# SPRINGS AT WATERVIEW PRELIMINARY PLAN

LOCATED IN THE NW 1/4 OF SECTION 7, T15S, R65W OF THE 6TH P.M.,  
EL PASO COUNTY, STATE OF COLORADO

SP-16-005

# Markup Summary

SHEET TITLE TITLE SHEET

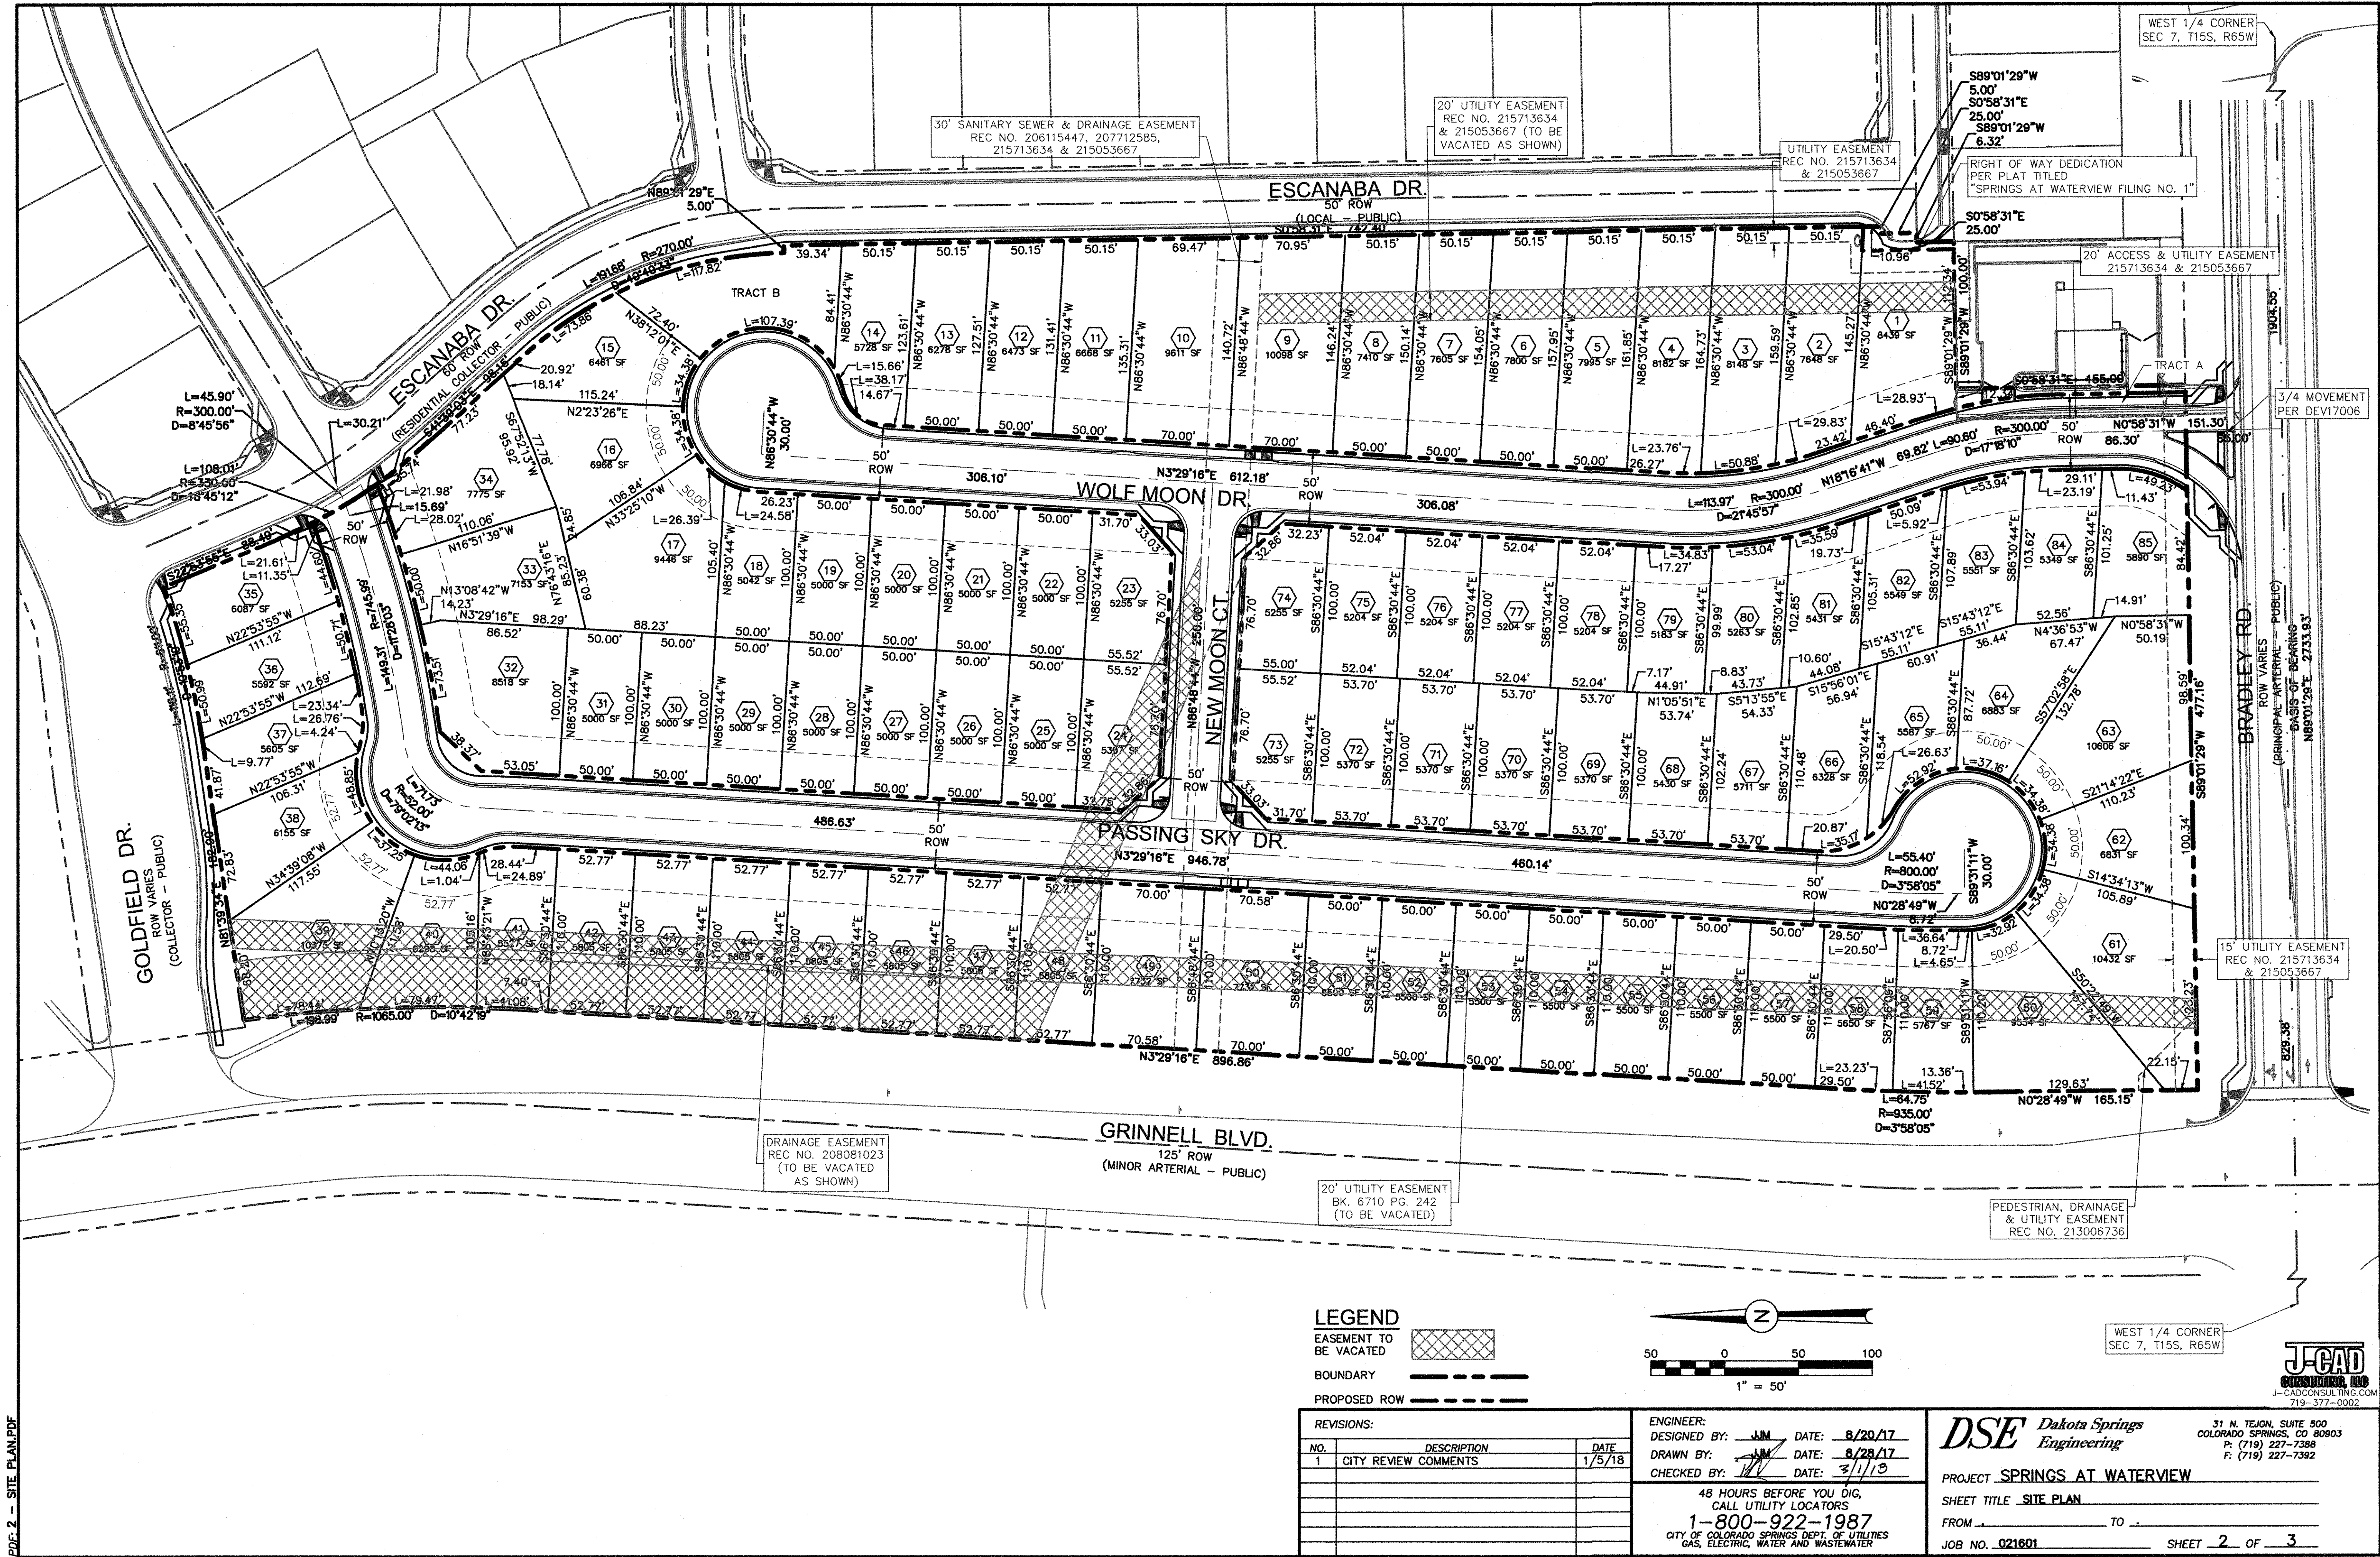
**Subject:** Callout  
**Page Label:** 1  
**Lock:** Unlocked  
**Author:** dsdruiz

RS-5000
